STATE SIGNIFICANT DEVELOPMENT ASSESSMENT REPORT:

Redevelopment of the Australian Technology Park, Eveleigh

SSD 7317

Environmental Assessment Report
Section 89H of the *Environmental Planning and
Assessment Act 1979*

Figure 15: Overshadowing of the Alexandria Child Care Centre (Source: applicant's RTS)

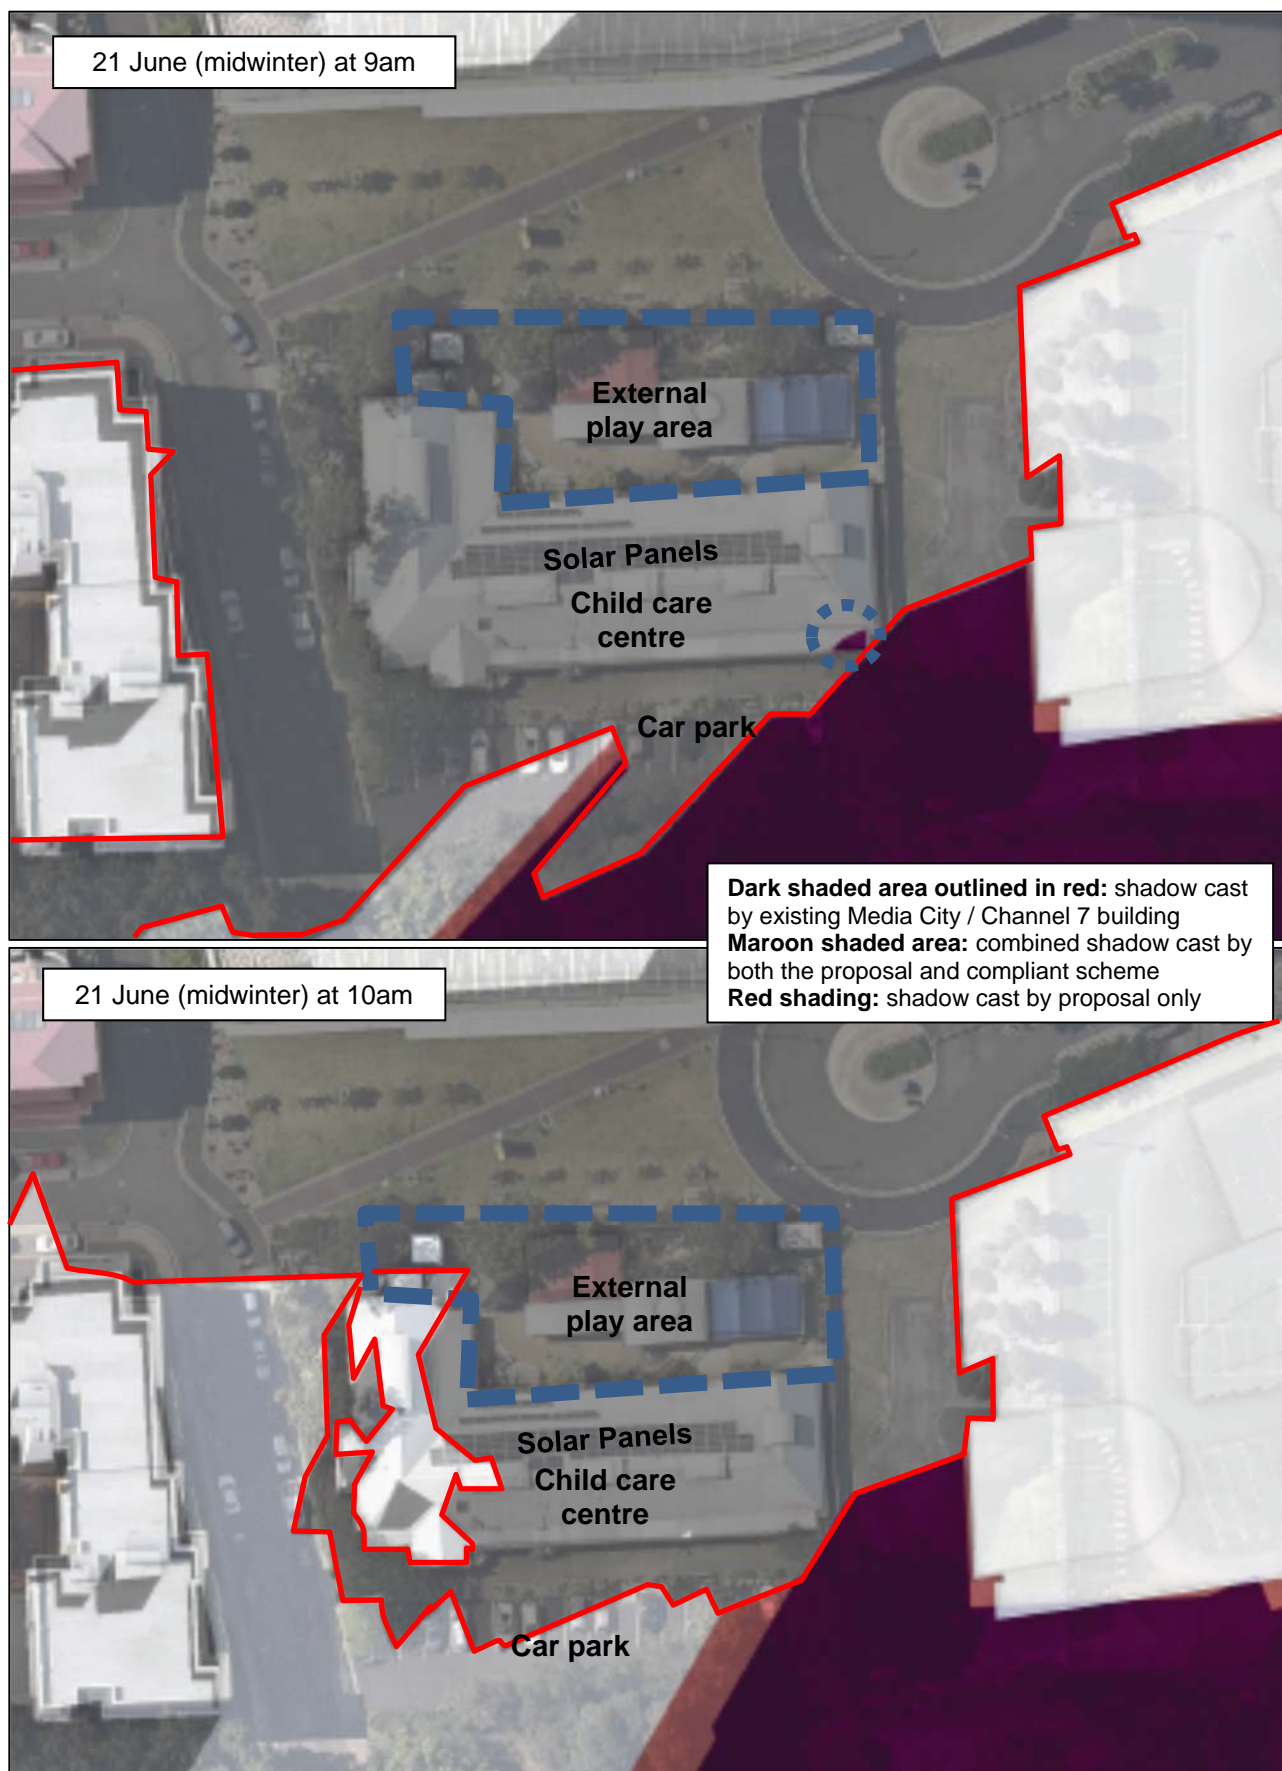
The applicant's overshadowing analysis indicates the proposal will not adversely overshadow the adjoining child care centre and its associated external play space and solar panels. This is

because the shadow cast by the proposal falls within the shadow already cast the existing Media City / Channel 7 building to the north (**Figure 15**).

The Department also notes the proposed scheme will overshadow an area of the car park to the south of the child care centre building (**Figure 15**). However, this overshadowing will not impact on the amenity of the centre or its external play area, and will pass by 11am in midwinter.

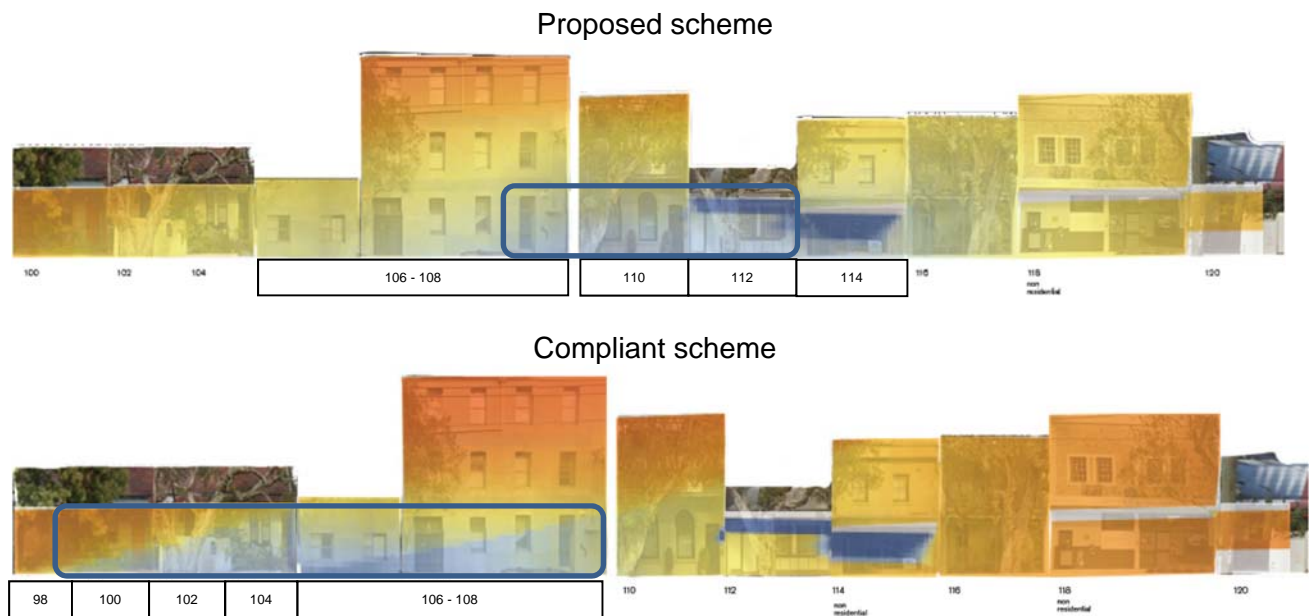
The applicant's analysis shows that parts of three residential properties to the south of Henderson Road (namely Nos. 106-108, 110 and 112) will not achieve this as a result of the proposal, compared to five properties as a result of a height and GFA compliant scheme (namely Nos. 98, 100, 102, 104 and 106-108) (**Figure 17**). The applicant's analysis also shows that all skylights will receive at least two hours of direct sunlight between 9am and 3pm in midwinter.

The Department has carefully considered the applicant's sunlight analysis against the requirements of the DCP. While it shows the proposal will not result in additional overshadowing impacts beyond that of a compliant scheme, the Department notes that, in addition to including the maximum allowable height and GFA, the compliant scheme used for the modelling includes several design features that enhance bulk and height to the building and subsequently result in additional overshadowing impacts. These include:

Figure 18: Concept diagrams showing area of Building 1 to be removed in blue (Source: applicant's additional information)

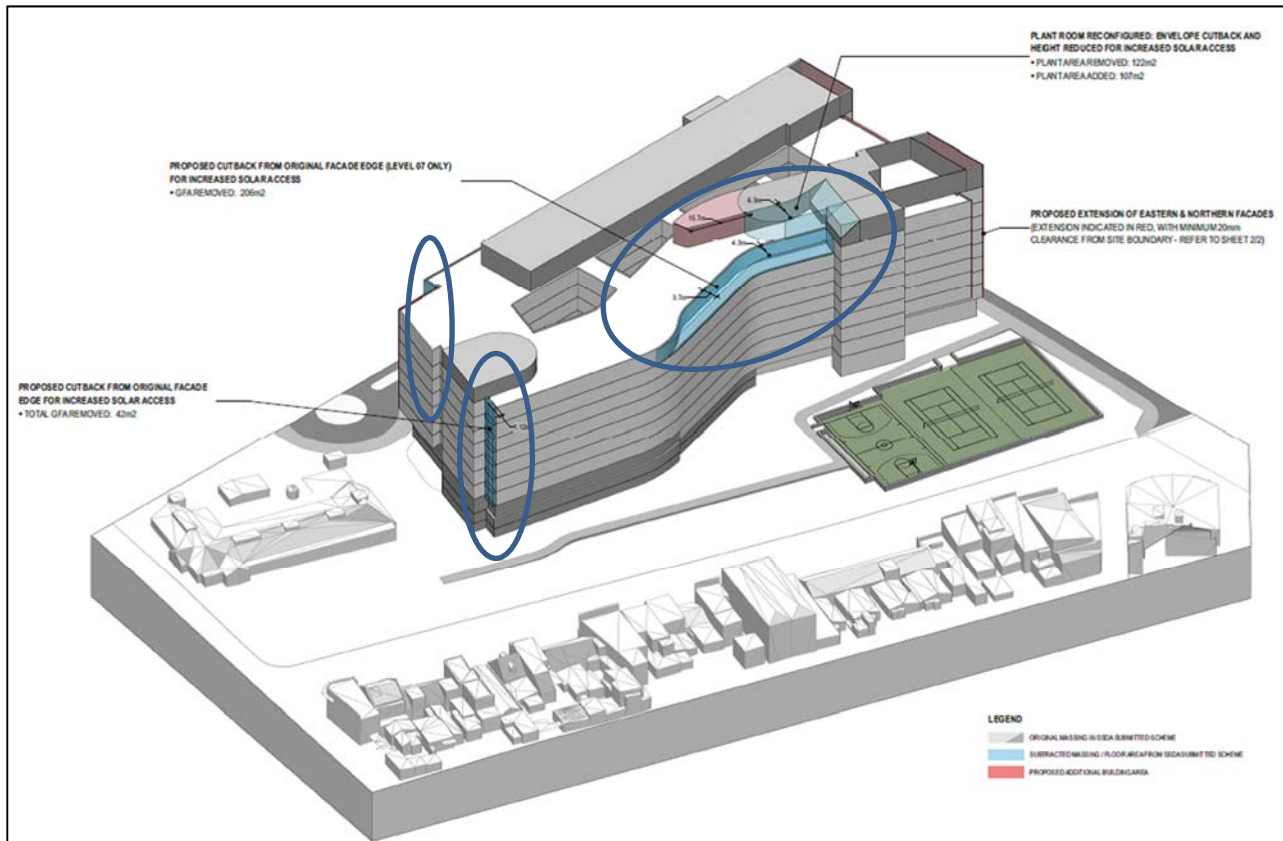
The Department therefore does not accept this analysis is sufficiently robust to provide justification for significant overshadowing impacts associated with the proposed exceedance of the height and GFA controls for the site.

Subsequently to forming this view, the Department requested the applicant amend Building 1 so that all residential properties to the south of Henderson receive at least two hours of direct sunlight between 9am and 3pm in midwinter. The applicant has provided concept diagrams and an updated shadow analysis showing the extent of amendments to Building 1 to achieve this requirement. These amendments include (as shown in blue on **Figure 18**):

- removal of 206m² GFA from the southern elevation at Level 7;
- removal of 53m² GFA from the northern and southern corner at Levels 1 to 7; and
- reconfiguration and removal of 15m² of the rooftop plant.

The applicant will need to amend the architectural drawings for Building 1 to reflect in detail the revised built form demonstrated in the concept diagrams (**Figure 18** and **19**), so that all properties to the south of Henderson Road receive at least two hours of direct sunlight between 9am and 3pm in midwinter. This is required through a recommended condition.

Figure 21: Proposed activation of the public domain at ground level (Source: applicant's RTS)

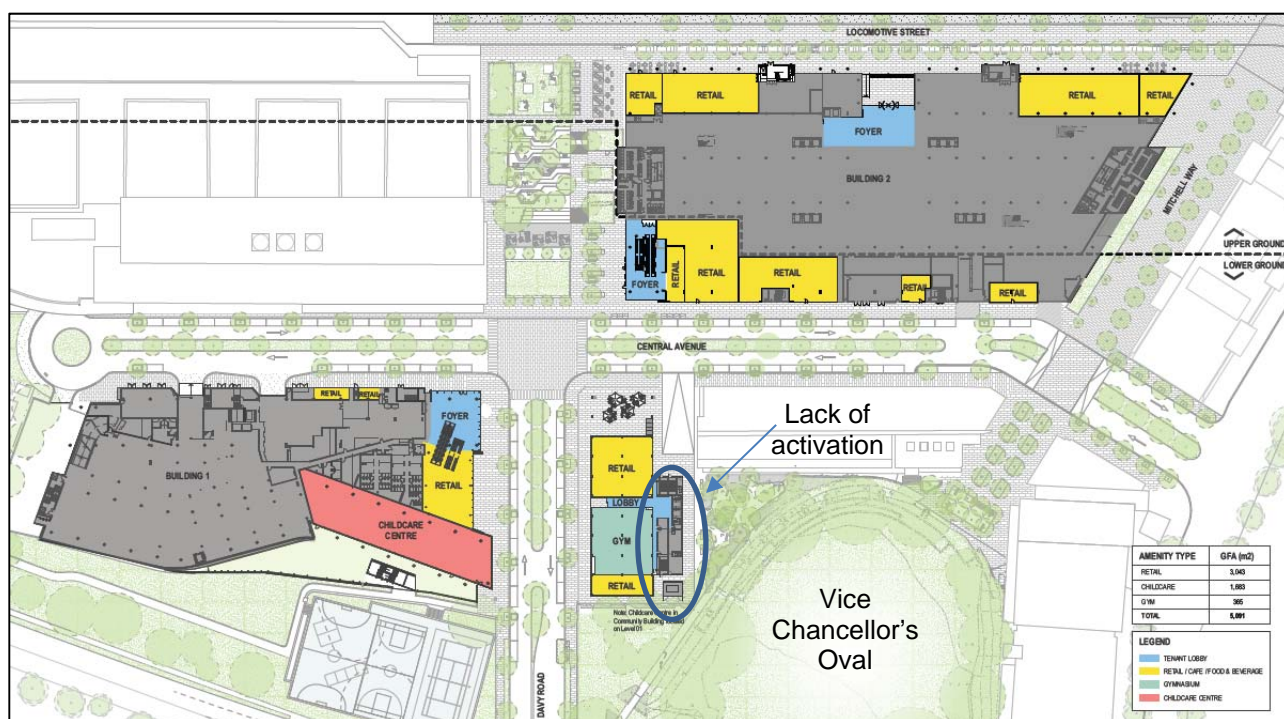
- the proposed buildings provide adequate ground floor activation in most locations fronting the public domain, especially in areas of high pedestrian activity being along the main pedestrian corridors and the squares (**Figure 21**);

The Department shares Council's concerns that the predominantly solid façade of the stair / lift core to the east of Building 3, together with the proposed substation to the south east of the building, will not sufficiently activate the public domain in the north western corner of the Vice Chancellor's Oval (**Figure 21**). This is particularly important as the building in this location presents genuine urban design opportunities to provide improved activation of the public domain.

The Department notes the proposed child care facility on Level 1 provides some limited activation to the adjacent public domain. In the RTS, the applicant has replaced some gym floor space on the ground floor to the south of Building 3 with retail, however this does not increase activation to the public domain to the east of the building (**Figure 21**). The Department therefore considers that further design amendments are required to increase activation and improve the amenity of the public domain. A condition is therefore recommended requiring the removal or relocation of the proposed substation and design amendments to increase activation of the south east corner of Building 3.

The Department is satisfied that, subject to the recommended conditions, the form and external appearance of the three buildings will enhance the quality and amenity of the public domain.

Figure 25: Car park and loading dock entry points for Building 1 (top) and Building 2 (bottom), with the area requiring reconfiguration shown in blue (Base source: Applicant's RtS)

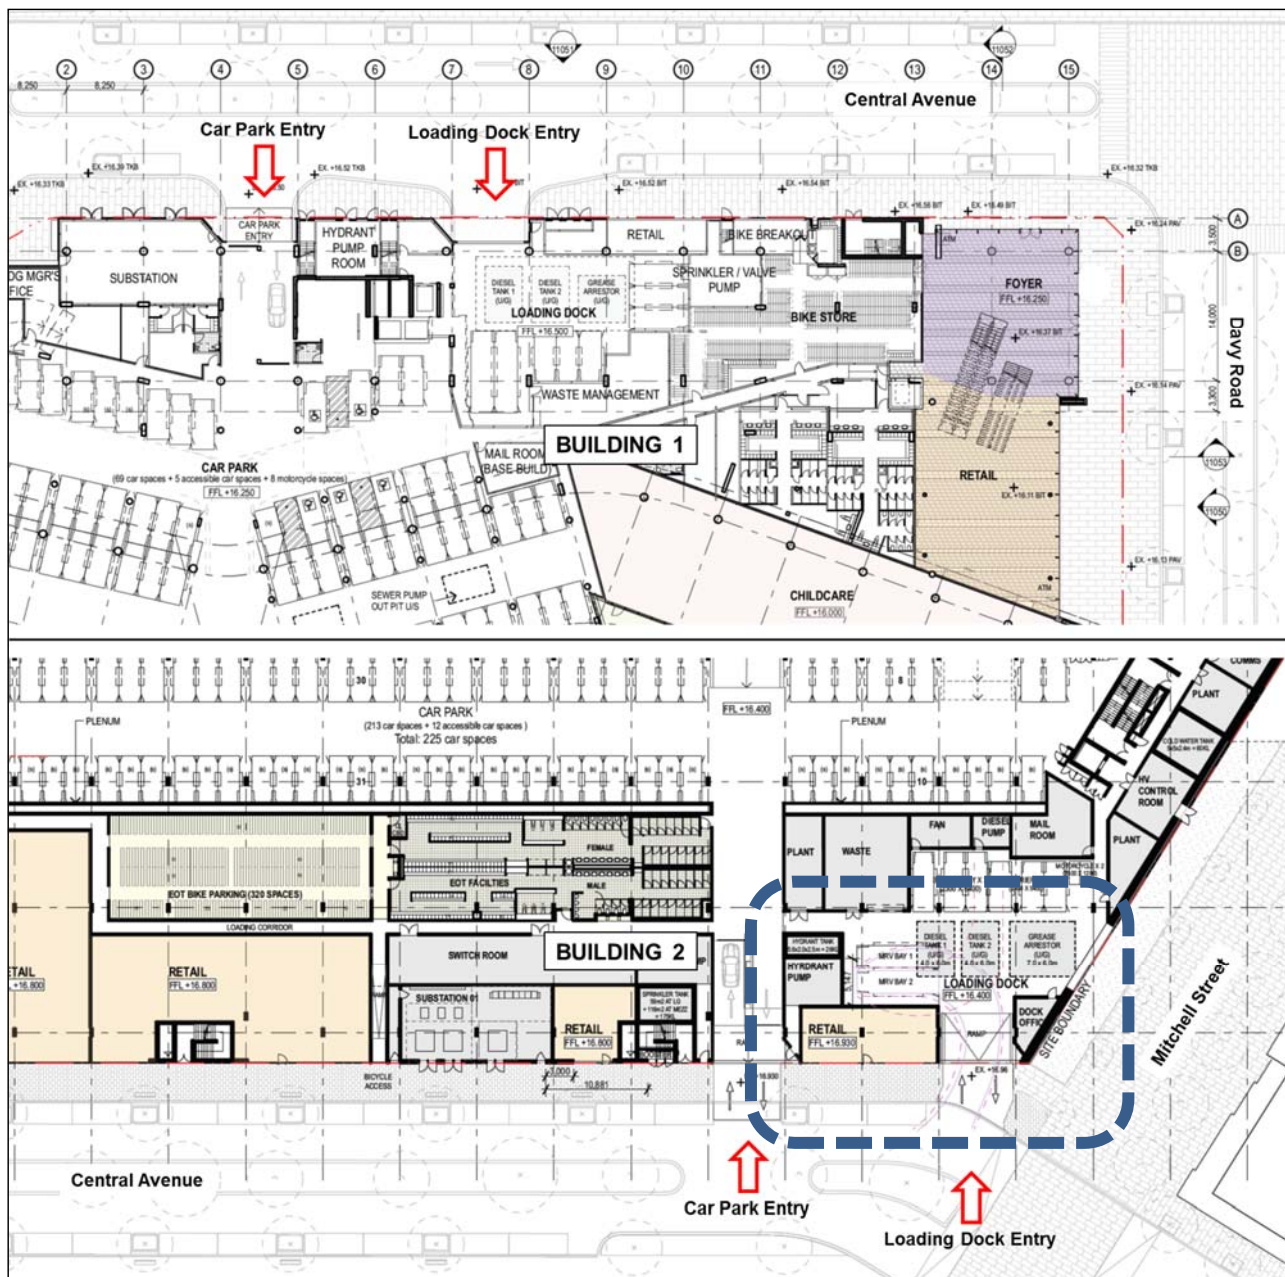
Council has raised concern that the multiple driveways for each building have a negative impact on pedestrian amenity and safety and recommends that each building's car parking and loading dock be accessed via a single vehicular access.

In addition, there is no right hand turn available into the loading dock from Central Avenue due to a proposed road island and plantings located opposite the entry. This will cause large vehicles entering from Garden Street to the east to traverse along Central Avenue, past another key pedestrian intersection at Davy Road/Central Avenue to access the roundabout and enter the loading dock from a left hand turn. To ensure appropriate sight lines at key intersections, reduce vehicular movements through the site and to ensure pedestrian safety the Department considers the car parking and loading dock entrances for Building 2 should be consolidated into one vehicle access ramp located away from the Central Avenue / Mitchell Road intersection. The Department notes this may result in some minor reconfiguration of the internal plant (hydrant pump and tank) and that the retail unit on the south eastern corner of the building may in the future be enlarged to wrap around and activate this corner of the building.

The Department recommends a condition requiring the car park and loading dock entrances for Building 2 be combined and appropriately designed driveway crossovers be implemented. The Department also recommends a condition requiring a loading dock management plan to ensure the safe operation of the loading dock when integrated with the vehicular access.

Figure 32: Extract of proposed child cares (source: applicant's RTS)

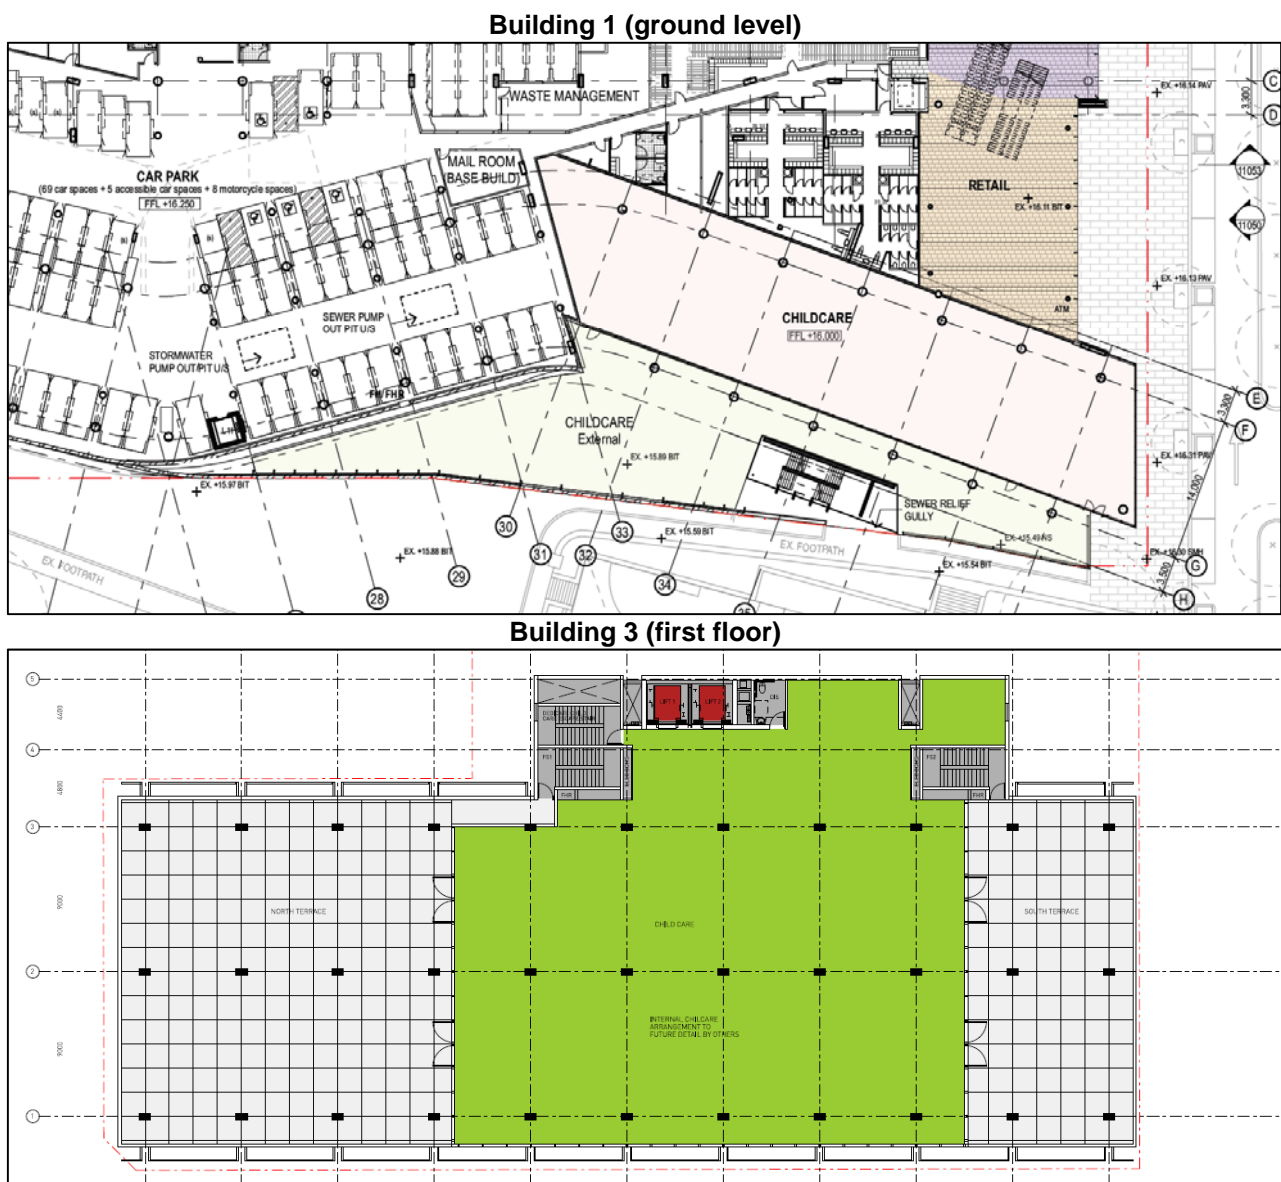
Council is concerned the external area of the child care centre in Building 1 lacks direct sunlight due to its southerly orientation and the location of the fire stairs within the play area reduces sight lines for carer surveillance.
